**Subject: Cell 1 and Landfill Site Certification Addendum 2
and Responses to Department Certification Comments
Enterprise Recycling & Disposal Facility
Angelo's Aggregate Materials, Ltd.
FDEP Permit Nos. 177982-001-SC, 177982-002-SO
Pasco County, Florida**

On behalf of Angelo's Aggregate Materials, Ltd. (Angelo's), Hartman & Associates, Inc. (HAI) is submitting responses to the Department's comments, dated December 8, 2003, regarding the certification submittals for the above referenced facility. Our responses are based on the discussion from our meeting with the Department on January 5, 2004. For your convenience, your comments are stated first with our responses, when applicable, following.

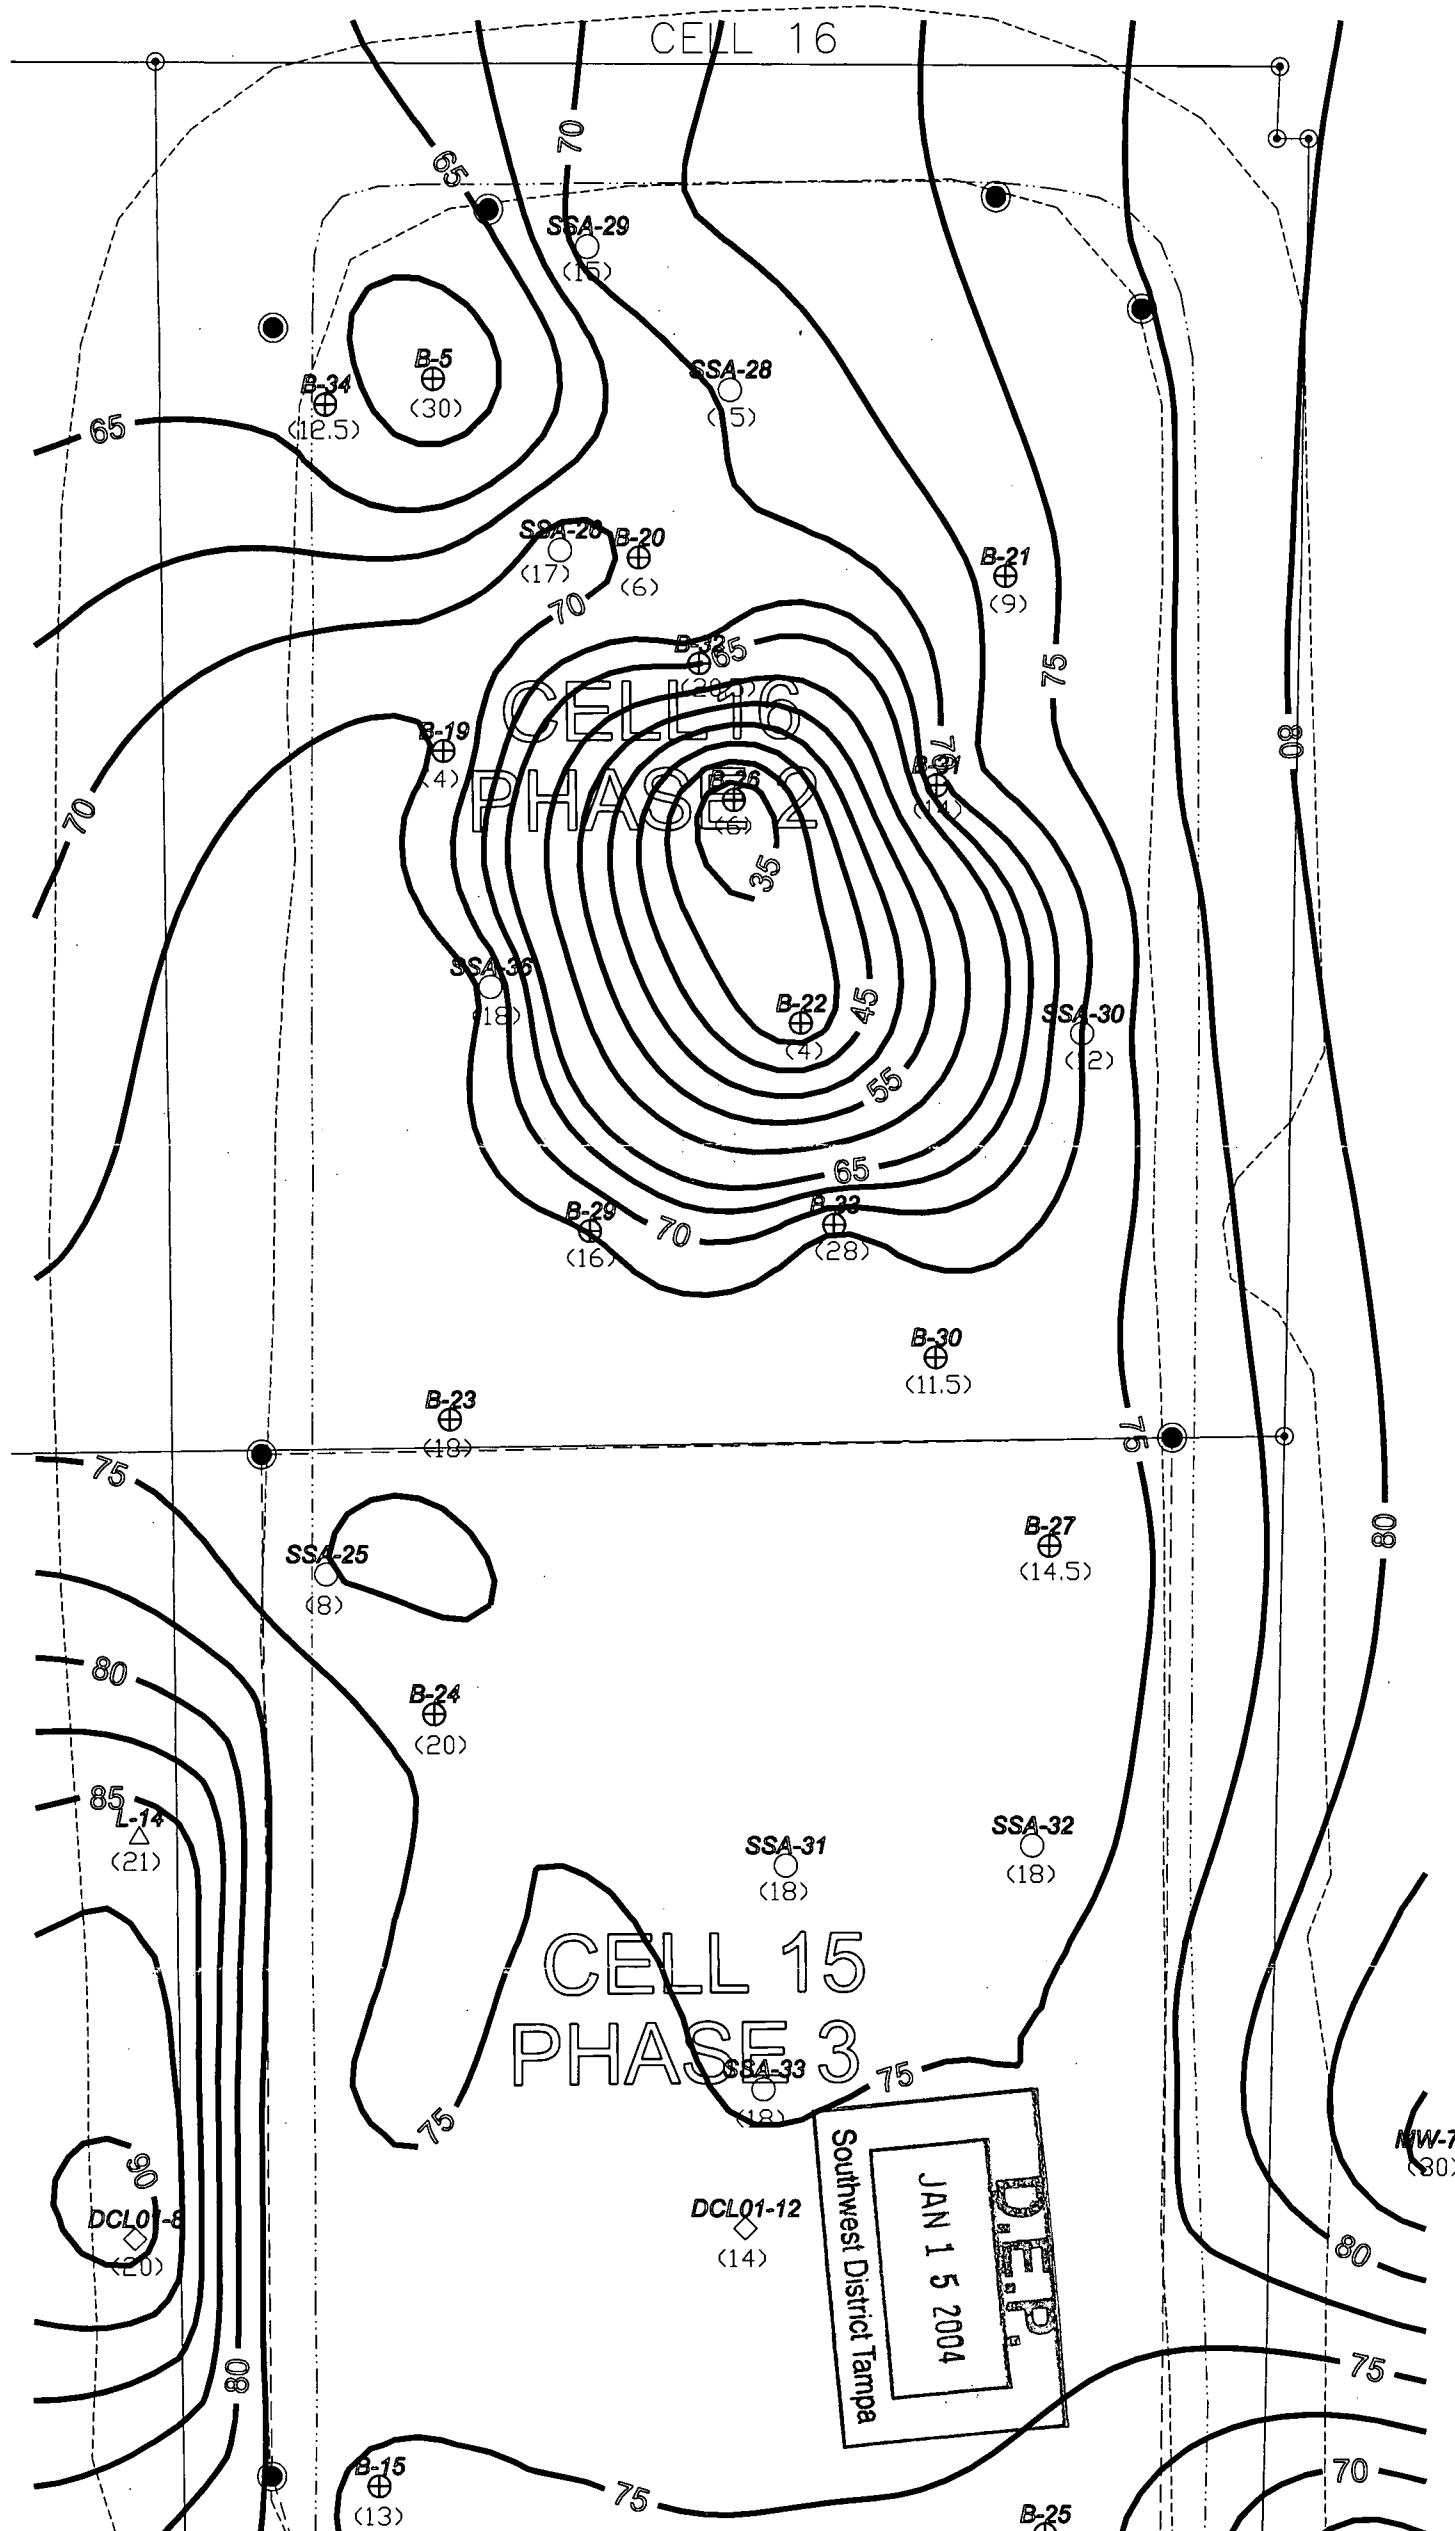
Figure 39 (Cells 15 and 16 clay layer/confining unit contour map) - *[This figure/map is based on a topographic survey (with both horizontal and vertical control) and is intended to show both the Cells 15 and 16 clay layer/confining unit contours and the locations of specific features (borings and the limits of the excavated cells). This figure/map shows that Cell 15 and Cell 16 are not completely excavated and there are no corner posts shown at the cell boundaries. The top of clay layer/confining unit contours dramatically change near the center of Cell 16, and the clay layer/confining unit thickness of at least 3 feet is not confirmed by an adequate number of borings. A top of the clay layer/confining unit drop of five feet between two borings spaced 100 feet apart is significant but acceptable when adequate thickness and permeability are confirmed. However, the top of the clay layer/confining unit drop of 30 feet in 100 feet (from B-33 to B-22) is dramatic and must be confirmed by additional borings and permeability tests. Therefore, the clay layer/confining unit thickness of 3 feet at the bottom of B-22 is of concern, and reasonable assurance of at least 3 feet of thickness must be provided by more closely spaced borings and/or greater than 3 feet of thickness. More continuity between borings allows for more widely spaced borings. Less continuity and dramatic changes requires more closely spaced borings. For areas with dramatic changes (such as those shown for Cell 16), additional borings on a grid of 50 feet are suggested. The certified area should be provided on one drawing (drawn to scale) and limited to the area completely excavated and prepared for waste disposal, and the limits of waste disposal/certified area must be marked by corner posts. All borings must be shown on all top of clay layer/confining unit contour maps. The scale of 1"=100' appears to be incorrect and must be corrected. A scale of 1"=60' is suggested, same as for the cross-sections. Related comments are provided in items 1)k), 1)l), and 1)n) of this letter.]*

Response: Figure 39 has been revised as discussed during the January 5 meeting to demonstrate the presence of the required confining material within the designated area to be certified at this time (Cell 15) and is attached in Appendix B. Also as discussed in the meeting, a temporary two-foot berm has been constructed along the cell boundary of Cell 15/Cell 16. The limits of certification are included in this figure as a dashed line in Cell 15. This will allow for the appropriate confining unit patching to be completed for later certification of Cell 16. The scale of 1"=100' has been changed to 1"=80. The scale used for this figure was chosen to display the area of interest in a standard 11" x 17" format.
